Re: Bayside Council Submission: Eden Street, Arncliffe Mixed Use Redevelopment

STATE SIGNIFICANT DEVELOPMENT EDEN STREET ARNCLIFFE REDEVELOPMENT

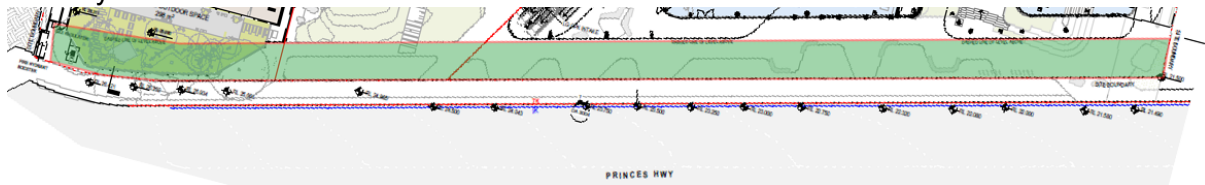
- The proposed residential flat buildings have large floor plates, with some lobbies containing up to 11 units. It is noted that windows are provided to all lobbies, however, the scale of the

lobbies will result in internalised corridors dependent upon artificial lighting. Further development of these circulation corridors is recommended, to embrace Apartment Design Guide (ADG) design criteria 4F 1.

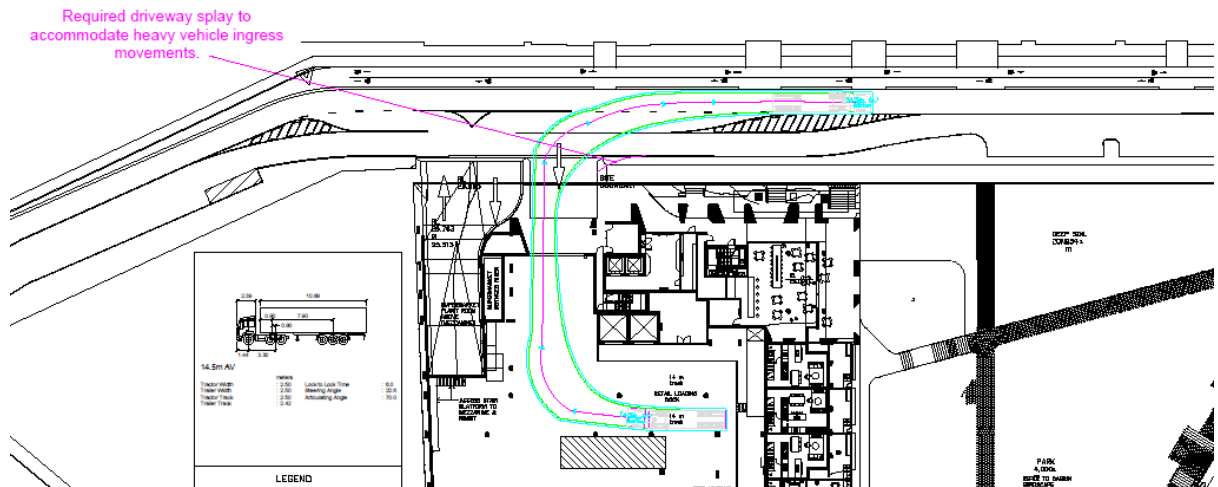
The proposed vehicular access design to Eden Street involves three driveways. These three driveways all placed adjacent to each other result in an excessively large 29m wide driveway that has significant detrimental impacts upon the public domain, and is not supported. Furthermore, these three driveways are all located at a significant bend of Eden street, where sight distances are significantly constrained.

This excessively large driveway width (29m) needs to be reduced in size whilst still functioning correctly as per Australian Standards. To achieve this, the design of the parking facility needs to be amended to facilitate the movements of service vehicles to the loading dock via the same driveway as the basement vehicular access.

Given the sight distance constraints identified in the traffic report associated with the bend in Eden Street's alignment, a Category 4 driveway access is not considered appropriate for the development and instead, a Category 5 vehicular access driveway (i.e., intersection) must be provided for this development. This aspect is already acknowledged in the traffic report. However, the current design of the intersection is not supported as it does not appropriately resemble an intersection.

The vehicular access needs to be entirely redesigned to properly reflect an intersection design as per AS/NZS2890.1:2004 section 3.1.1. This will require some opening up of the area and building around the intersection and the provision of a far longer length with a flatter gradient. Additionally, the intersection needs to be set back as far as feasibly possible from the bend in Eden Street. A safety concern is raised regarding the location of the southernmost driveway within close proximity to the bend on Eden Street. The sight distance of 50m to the south is inadequate and less than the required 69m, and the seagull treatment (s1.3.6) proposed does not fully mitigate risks.
